Stability Pathfinder Phase 2 FAQ

Updated 17/11/20

This document contains the questions submitted at the RFI stage from July 2020. We have updated some of the responses to reflect the latest information. As the EOI progresses we will update this document with EOI webinar questions and common questions we are receiving.

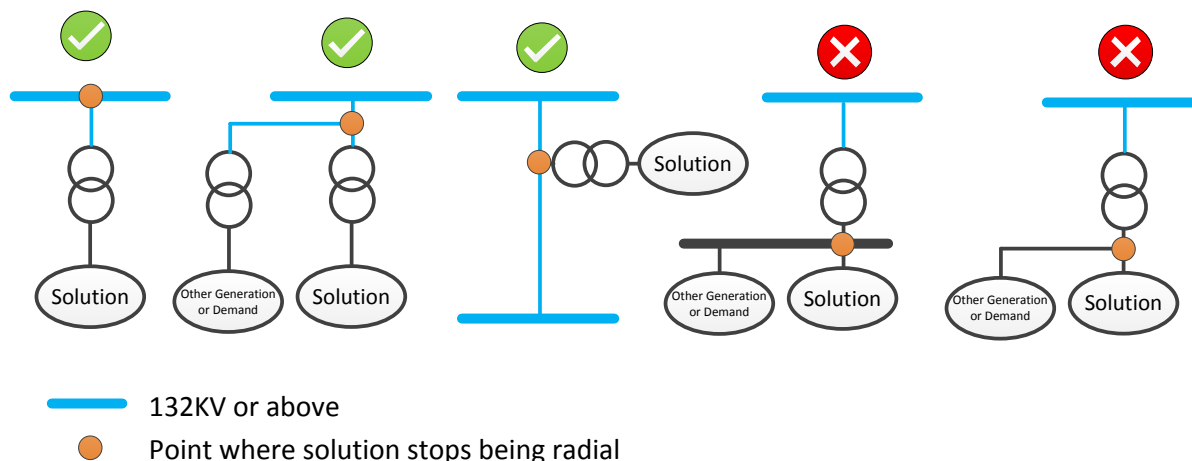
26. Why were these 8 locations picked? (added 06/11/20)

This is based on our system needs and studies. See Q13 for more information.
